**Re: Application for Site Plan Approval at 657 Saw Mill River Road  
(a/k/a Parcel No. 6.50-35 Lots 8, 9, 10, and 11)**

We are pleased to provide responses to the Village Consultant and NYSDOT review memorandums along with Board of Trustee and public comments. A digital copy of the full submission package will be provided to the Building Department via email. Accordingly, we have provided the below materials and responses for your consideration to be discussed at the next Town Board Meeting.

**MEMO from David B. Smith of Planning & Development Advisors –  
Site Plan Review 657 Saw Mill River Road  
December 12, 2023**

Drawn: **KRM** Approved: **RJP**  
 Scale: 1" = 20'  
 Date: 05/26/2020  
 Project No: 18175  
 1815-SE C-110-MOE 1A-VH-04  
 Drawing No:  
**C-110**

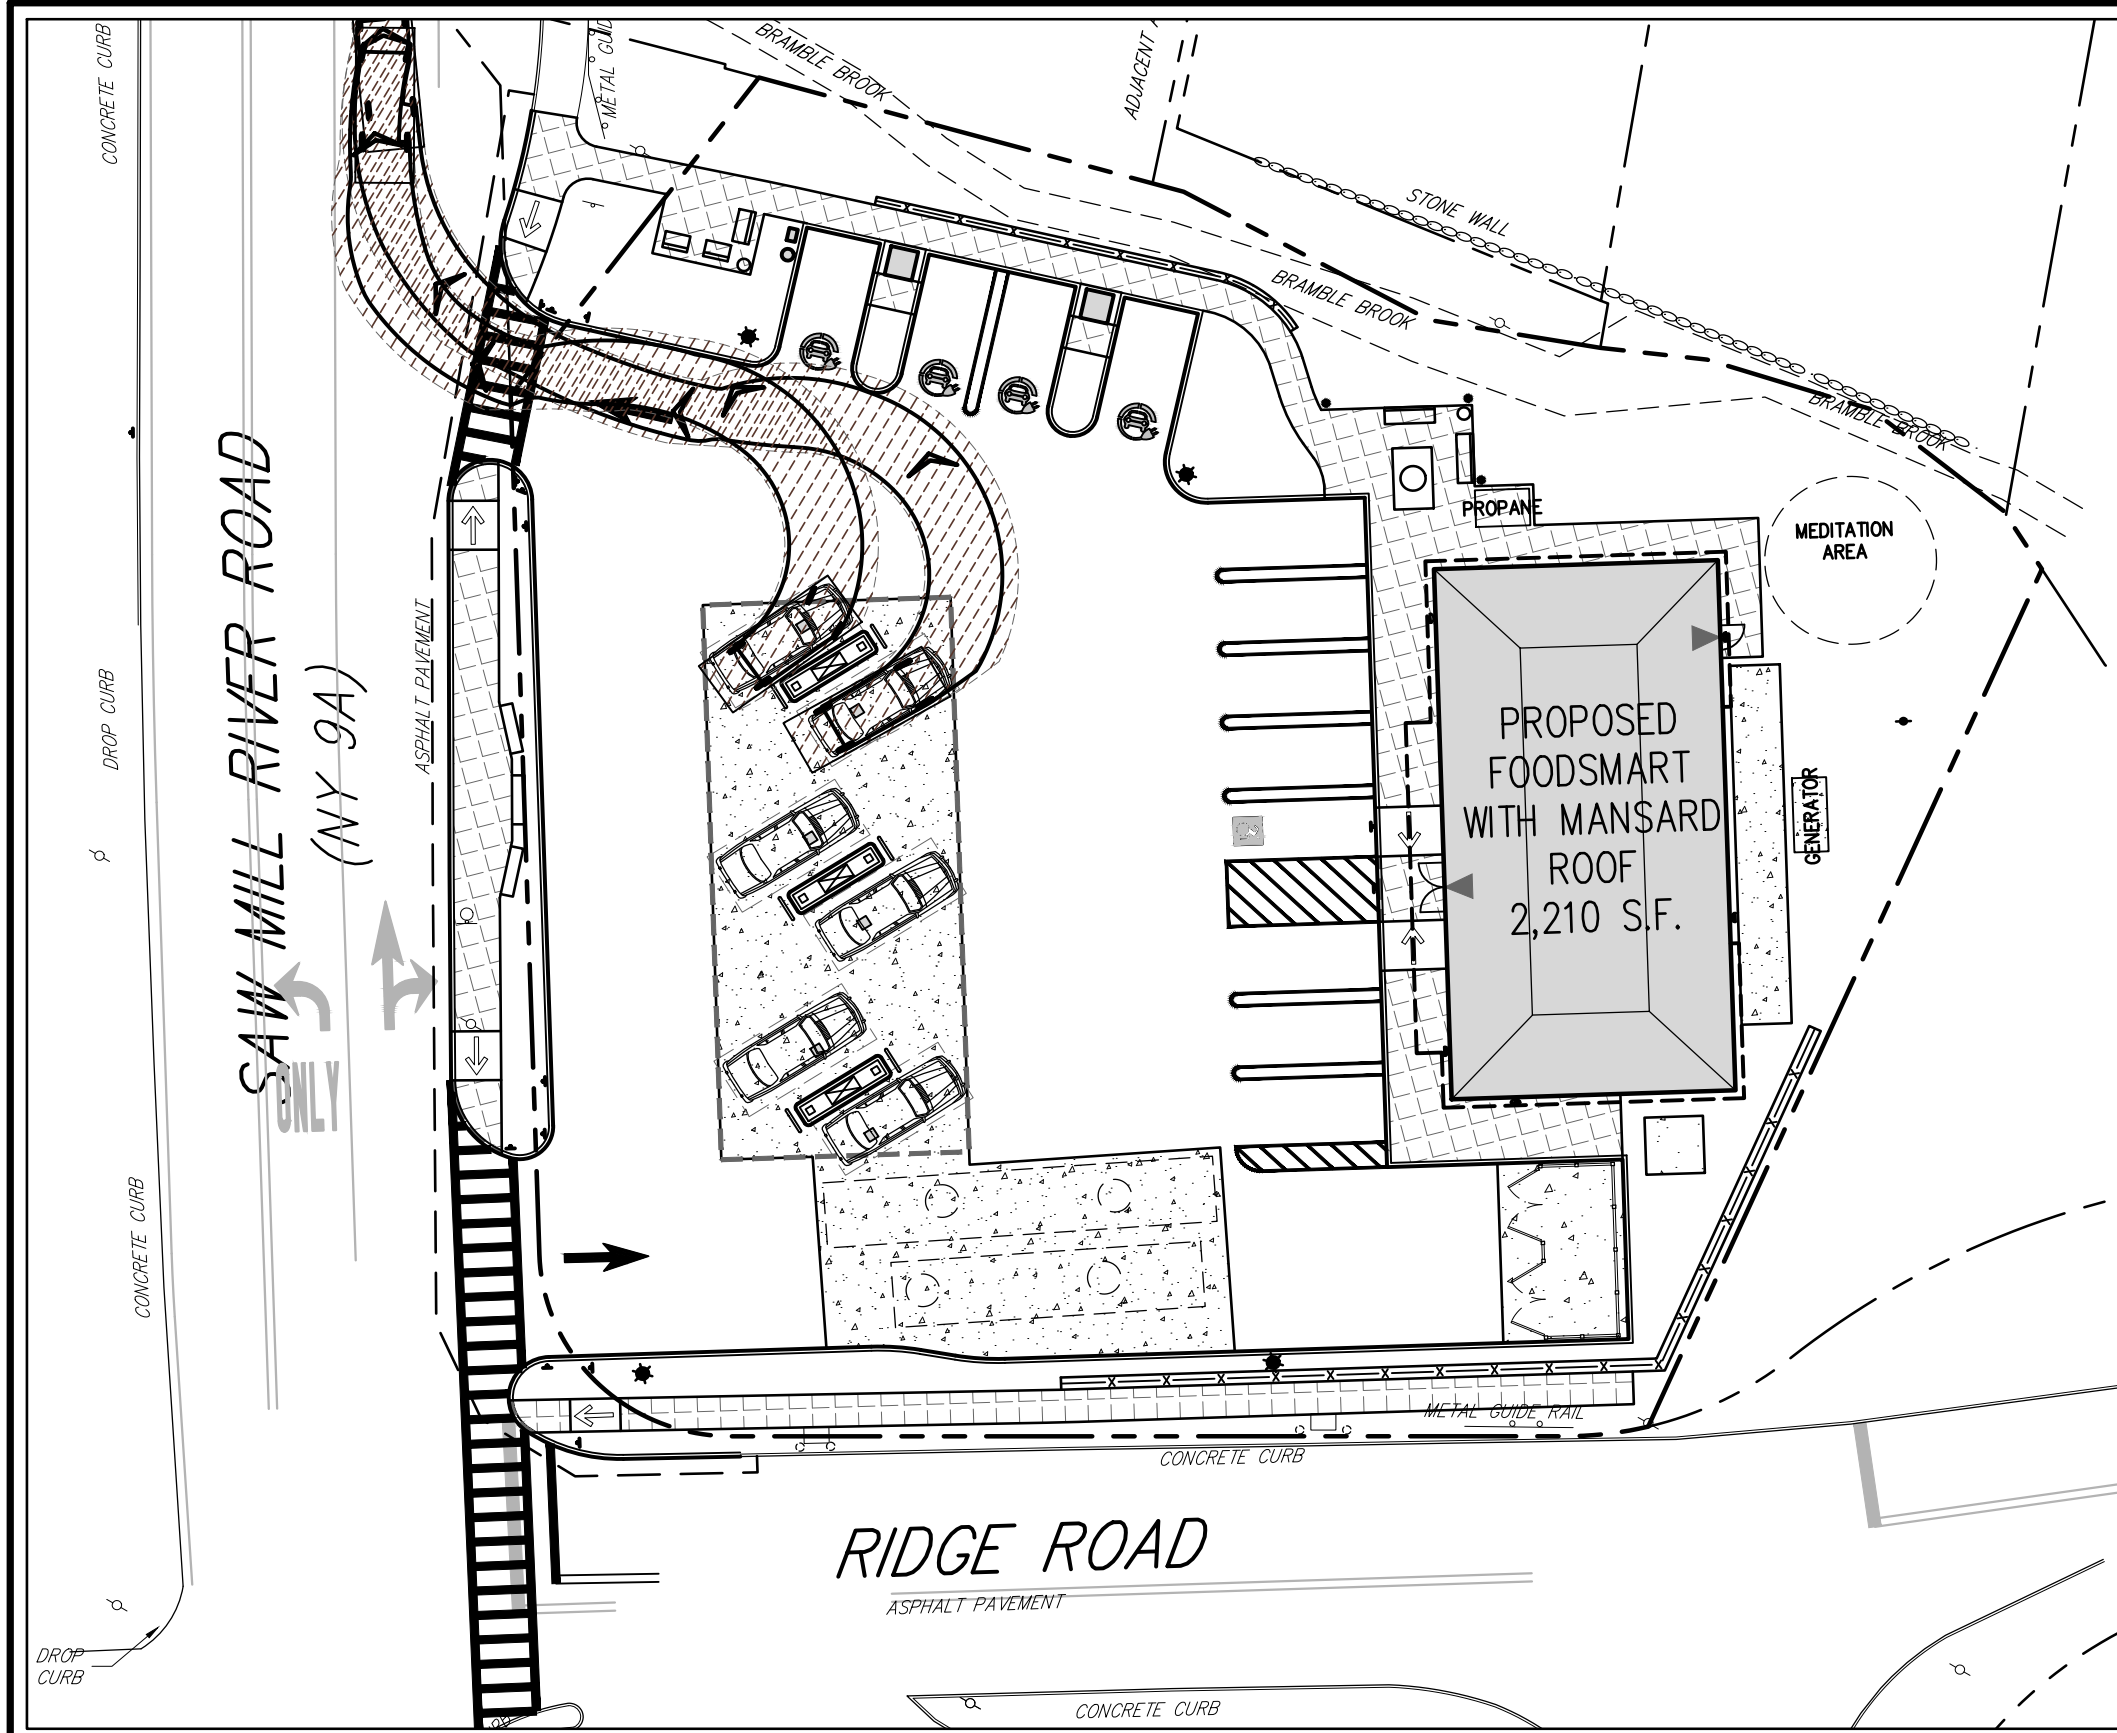
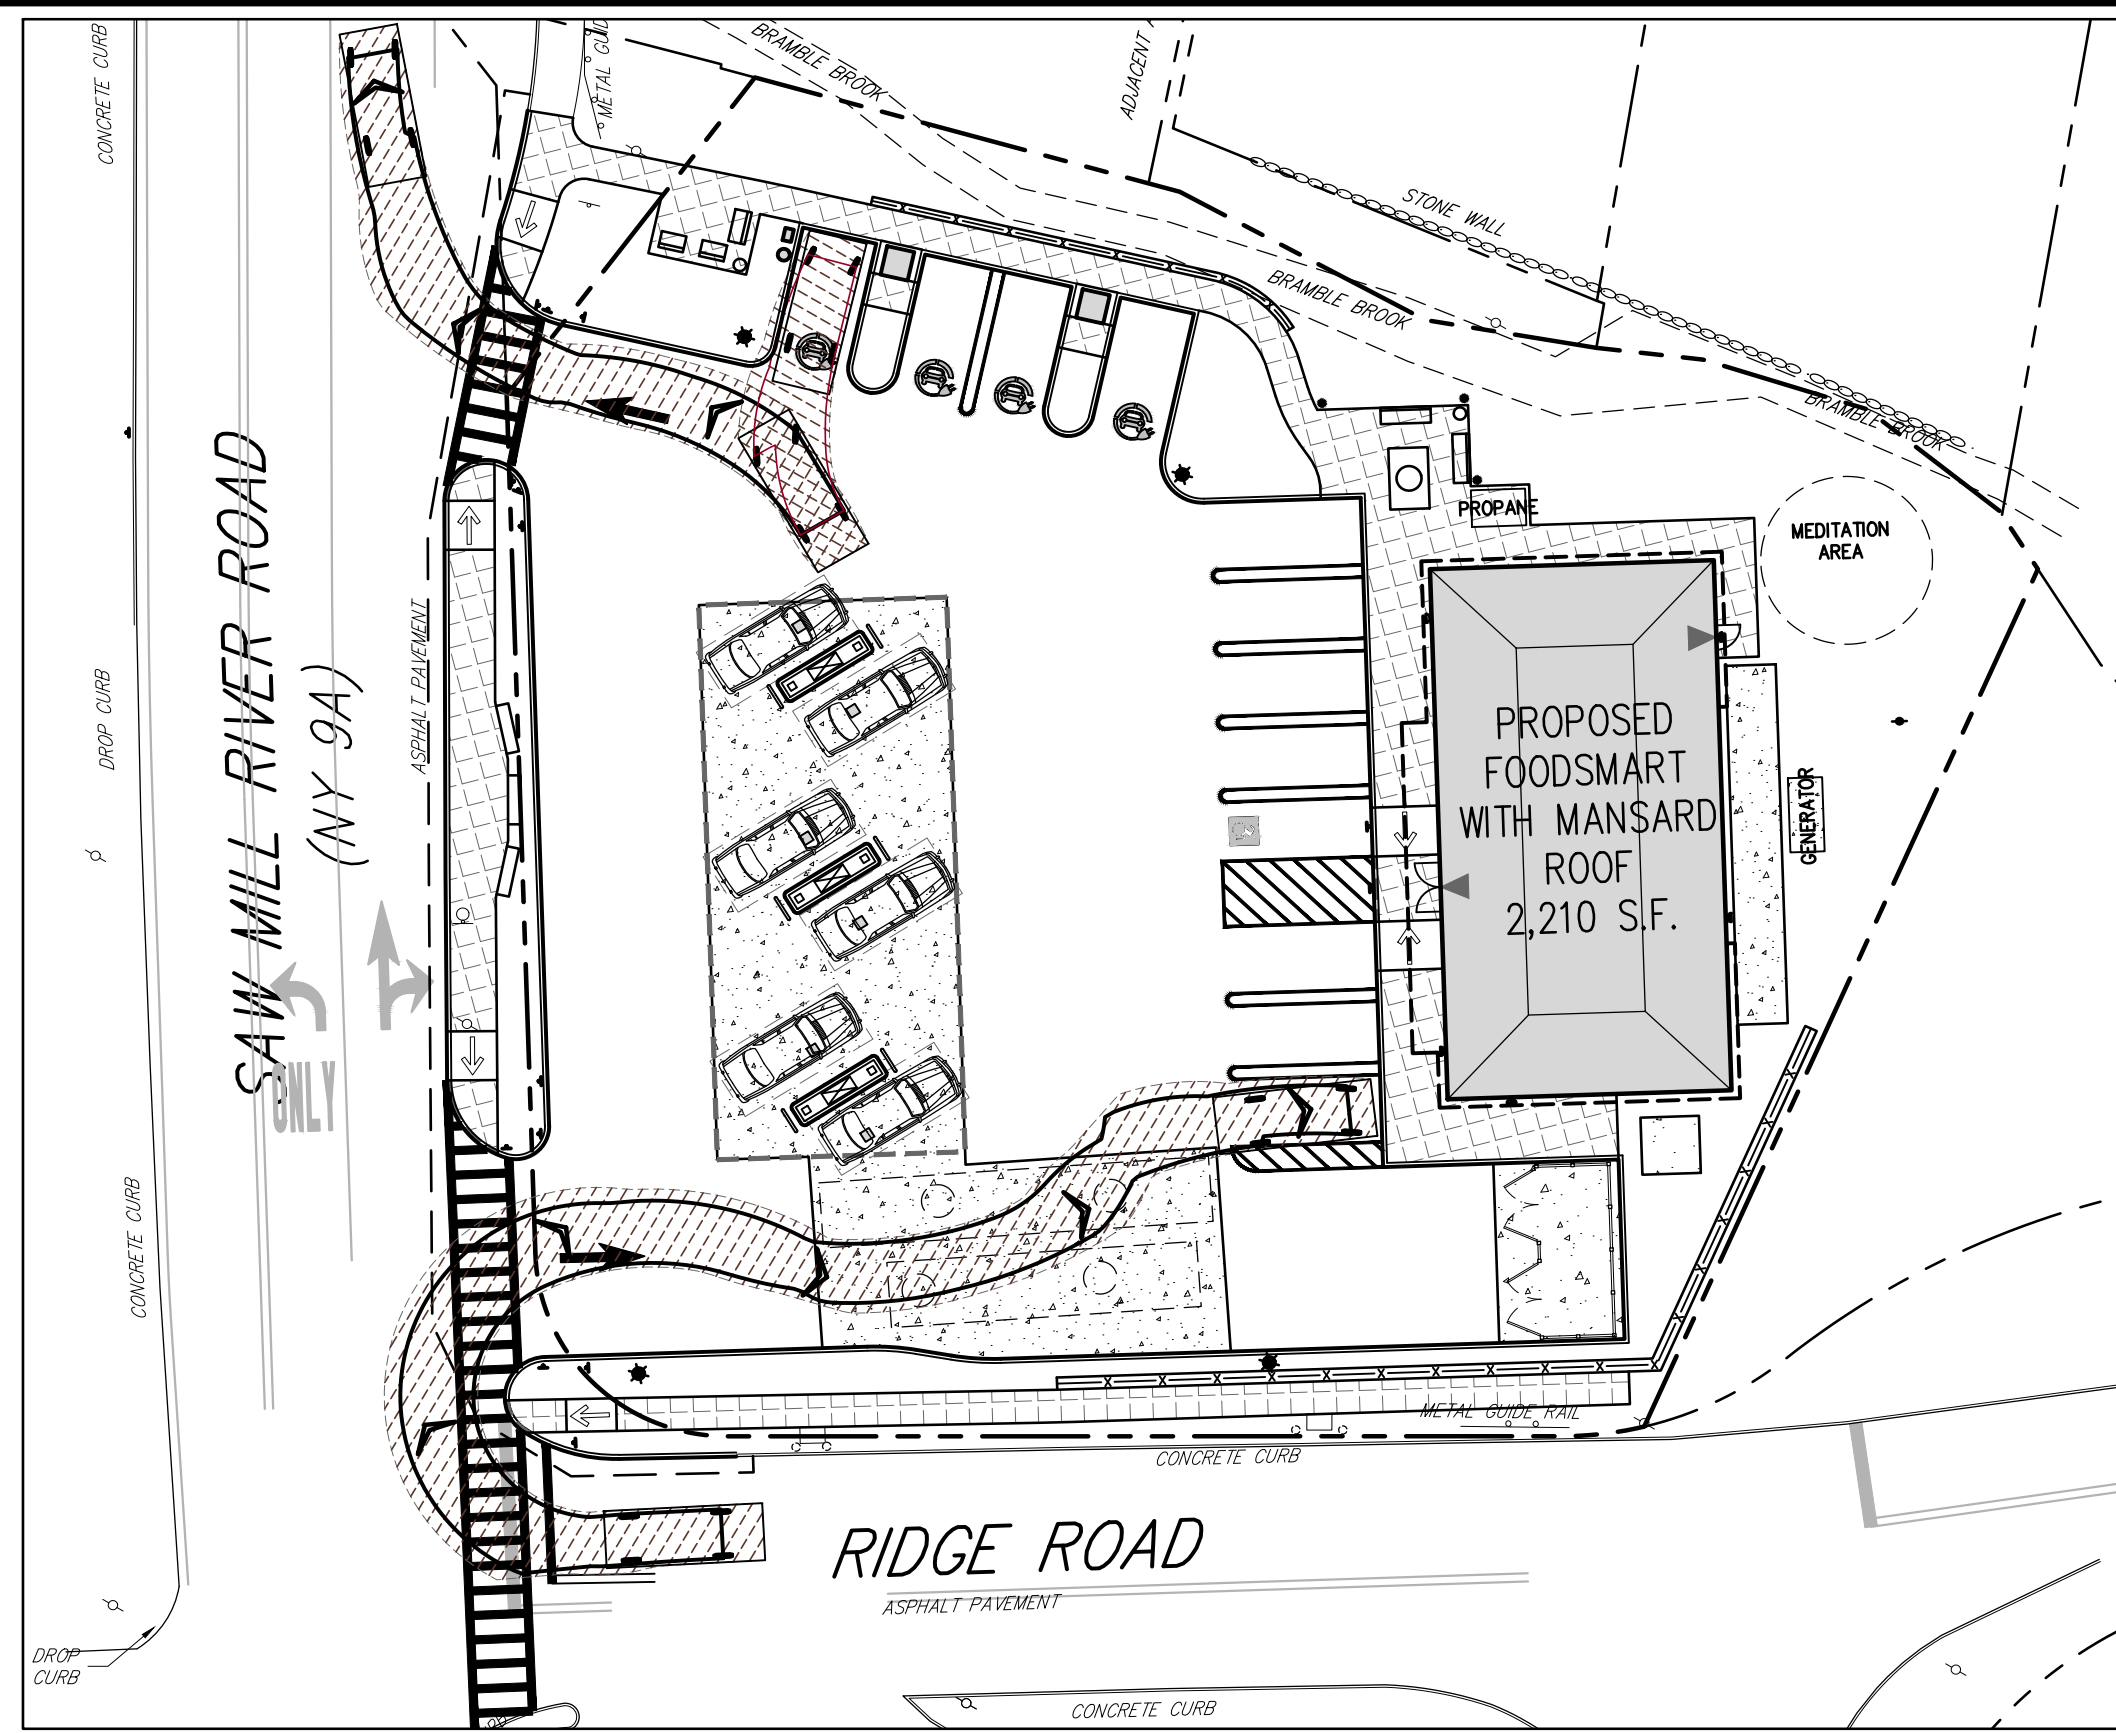
**Comment 1.** The applicant has prepared a Turning Analysis Plan, which examines the turning movements into and out of the property for passenger vehicles, tanker trucks and garbage trucks. The plan reflects interference with vehicles at the fuel pumps for tanker trucks entering the southern driveway from the south and exiting the northern driveway. The applicant should reexamine the southern entrance, in an effort to eliminate the present conflict between a tanker truck entering and a vehicle located at the most southern fuel dispenser. The applicant should also examine modifications to the site layout, which would permit tanker trucks exiting the property to avoid conflicts with a vehicle at the most northern fuel dispenser. It appears the

The Turning Analysis Plan also does not provide exit movements for vehicles utilizing the northern fuel island. The plan should be amended confirming that such a turning movement is obtainable.

Fuel Trucks - Drawing C-110 shows that a fuel truck coming from the south and turning into the southern driveway will have to drive over a portion of the sidewalk as well as on the paver section. This area is shown to be mountable but will they be able to support the weight of fully loaded fuel truck? The NYSDOT will also review this. It would be beneficial to have an employee present at the sidewalk to assist the fuel truck driver and to keep any pedestrians back due to the wide turn that has to be performed and the limited sidewalk length for someone who has just crossed Ridge Road.

The building has been pushed back as far as possible while still maintaining a 6' setback from the rear property line. The main drive aisle between the convenience market and the pumps has been widened by 10'. The southern driveway has been shifted south about 6.5', eliminating all previous conflicts. The need for a cobble stone paver infill and mountable curb has also been eliminated with this new proposed driveway location. Exit movements for vehicles utilizing the northern most fuel island have been added to JMC Drawing C-110 and a new JMC Drawing C-120.
